## SERVICE BULLETIN

ENGINE - FUEL AND CONTROL - MARKING OF THE EPR MODIFICATION CLASS NUMBER - CATEGORY  
CODE 5 - MOD.ENG-73-0025

# V2500-ENG-73-0025

Location of the engine identification plate  
Fig.2

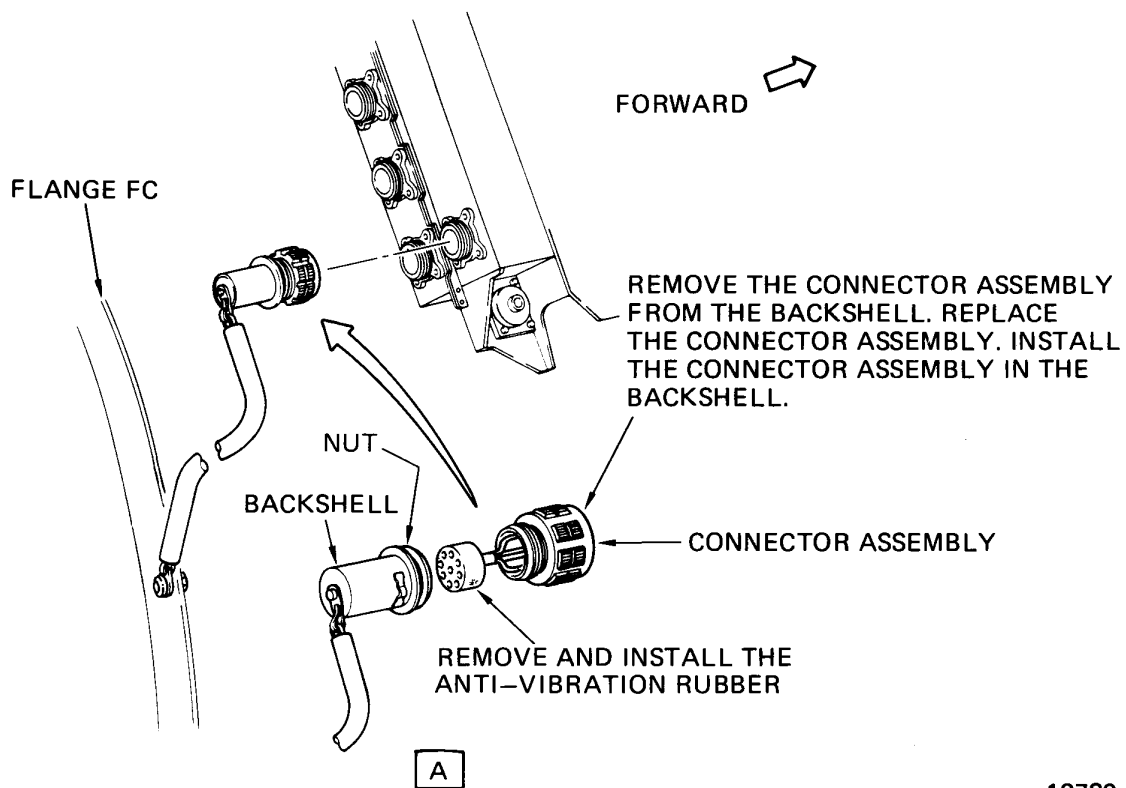
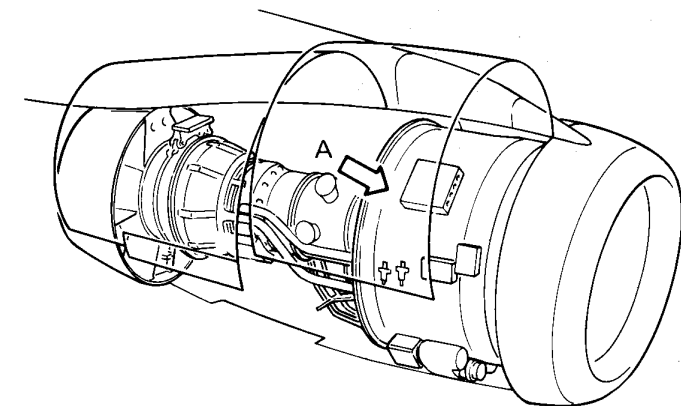
- (1) Replace the 5A9036 Engine Identification Plate (See Reference (1), Chapter/Section 72-32-85, Fig/Item No.03-120) as follows:

| (a) Remove the four bolts that hold the Engine Identification Plate to the bracket located on the fan case at the 9 o'clock position | Refer to Figure 2, requirements |
| (c) Get the new 5A9036 Engine Identification Plate from your IAE Representative  | Refer to Figure 2, requirements |

(d) Install the new Engine Identification Plate to the bracket with the 4W0102 Bolts (4 off) Refer to Figure 2, requirements

(e) Torque the bolts between 32 - 36 lbfin (3,61 - 4,07 Nm) Refer to Figure 2, requirements

Modification and identification of data entry plug assembly  
Fig.1

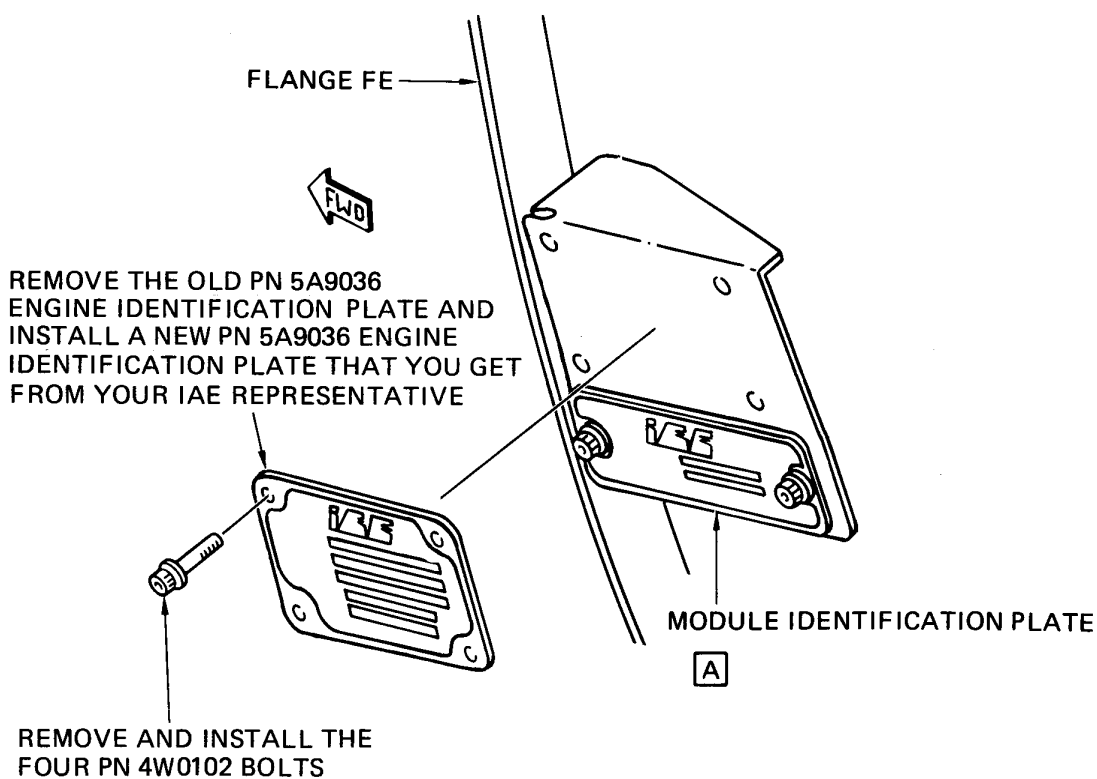
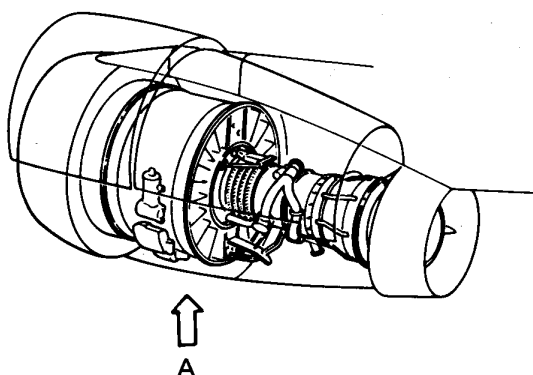
- (a) Data Entry Plug Connectors are replaced.
- (b) Data Entry Plug Backshells are marked with the correct EPR Modification Class Number.
- (c) Engine Identification Plates are replaced with new ones that show the correct EPR Modification Class Number.

- (1) Remove the lockwire from the Data Entry Plug Backshell.
- (2) Loosen the Backshell Nut, but do not remove the Backshell. Use a TG-70 Strap Wrench or equivalent.
- (3) Disconnect the Data Entry Plug Assembly from the EEC. Use the IAE 1J12018 EEC Harness Wrench. Refer to Figure 1.

| (g) Identify the Data Entry Plug Backshell with the New EPR Modification Class Number as follows:                            | Refer to Figure 1, requirements  |
| (ii) Mark EPR Class 06 on the Data Entry Plug Backshell, adjacent to the old EPR Class Number. Use the vibration peen method | Identify by the approved procedure in Reference (2), Control No./TASK 70-09-00-400-501 |

| (ii) | Mark EPR Class 08 on the Data Entry Plug Backshell, adjacent to the old EPR Class Number. Use the vibration peen method     | Identify by the approved procedure in Reference (2), Control No./TASK No.70-09-00-400-501 |

| (ii) Mark EPR Class 09 on the Data Entry Plug Backshell, adjacent to the old EPR Class Number. Use the vibration peen method | Identify by the approved procedure in Reference (2), Control No./TASK No.70-09-00-400-501 |

| (i) Tighten and torque the Data Entry Plug Assembly to 32 lbfin (3,6 Nm). Use the IAE 1J12018 EEC Harness Wrench             | Use the procedure in Reference (2), Control No./TASK 70-41-00-400-501                  |
| (j) Tighten and torque the Backshell to 53 – 58 lbfin (5,99 – 6,55 Nm) with a TG-70 Strap Wrench or equivalent               | Use the procedure in Reference (2), Control No./TASK 70-41-00-400-501                  |
